UNITED STATES PATENT AND TRADEMARK OFFICE

Office Action Summary

10/082,479

GIAMPAVOLO, PAUL

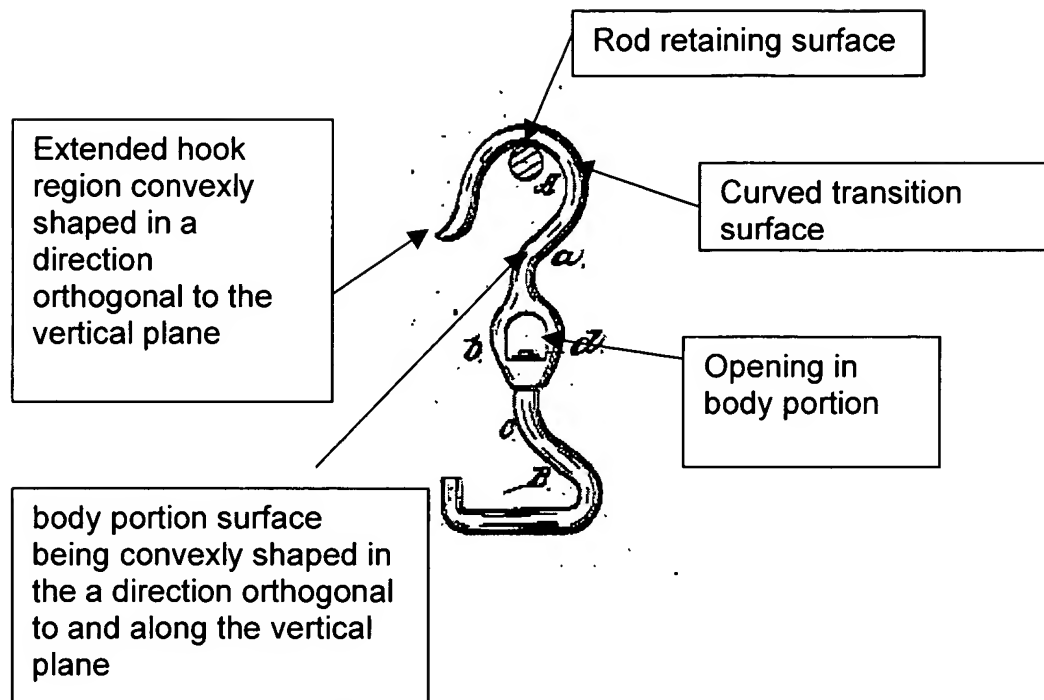
Claims 29 and 35 are rejected under 35 U.S.C. 103(a) as being unpatentable over Ursitti (U.S. patent no. D395,555) in view of Oatley (US patent no. 70,884). Ursitti discloses a device for garment having a hook portion and a body portion with opening and a strap threaded through the opening. However, Ursitti does not disclose an extended hook region surface is convexly shaped in the direction orthogonal to the vertical plane passing through a center of the extended hook region surface, wherein the body portion surface is also convexly shaped in the direction orthogonal to the vertical plane such that a size of the hook opening decreases towards a point and thereafter increases. Oatley teaches a hook with an extended hook region surface is convexly shaped in the direction orthogonal to the vertical plane passing through a center of the extended hook region surface, wherein the body portion surface is also convexly shaped in the direction orthogonal to the vertical plane such that a size of the hook opening decreases towards a point and thereafter increases. (see illustration below).

It would have been obvious to one of ordinary skilled in the art to have made Ursitti's hook apparatus from wire or rod type material such that the convex shaped surfaces and the particular design shape of the hook is achieved as such material for making hooks is old and well-known and conventional as demonstrated by Oatley.
